Plugging Program for South Blanco Federal 25-7:

Re: Permanent Abandonment Well: 7 South Blanco Federal 25

CONDITIONS OF APPROVAL

Wellbore Diagram

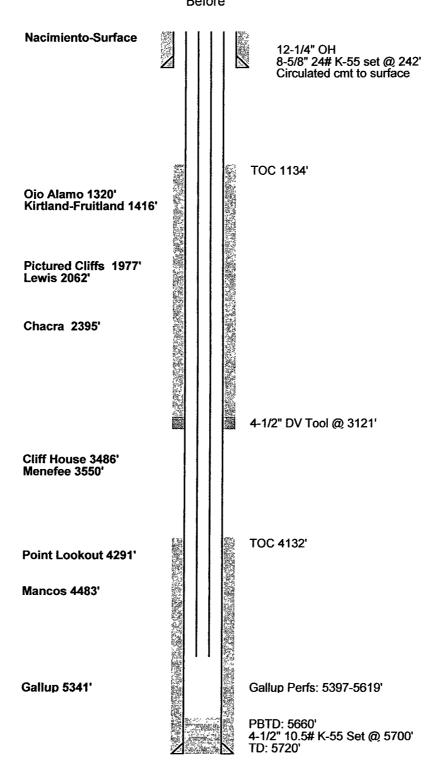
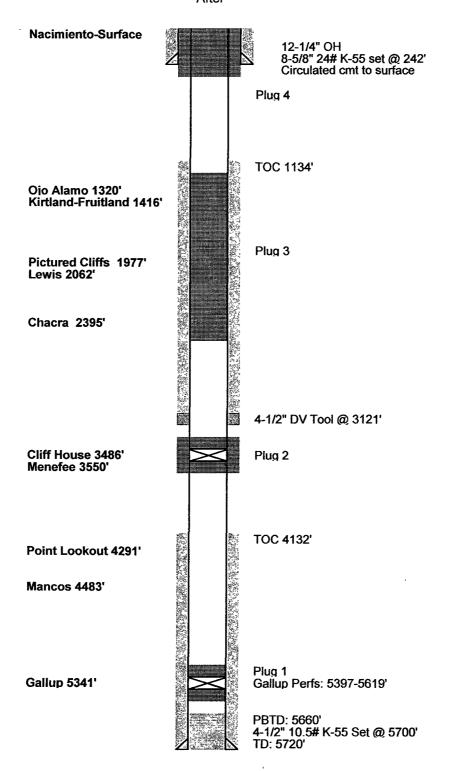
- 1. Plugging operations authorized are subject to the attached "General Requirements for Permanent Abandonment of Wells on Federal and Indian Lease."
- 2. Farmington Office is to be notified at least 24 hours before the plugging operations commence (505) 599-8907.
- 3. The following modifications to your plugging program are to be made:
- a) Place the Mesaverde plug from 2815' 2715'.

You are also required to place cement excesses per 4.2 and 4.4 of the attached General Requirements.
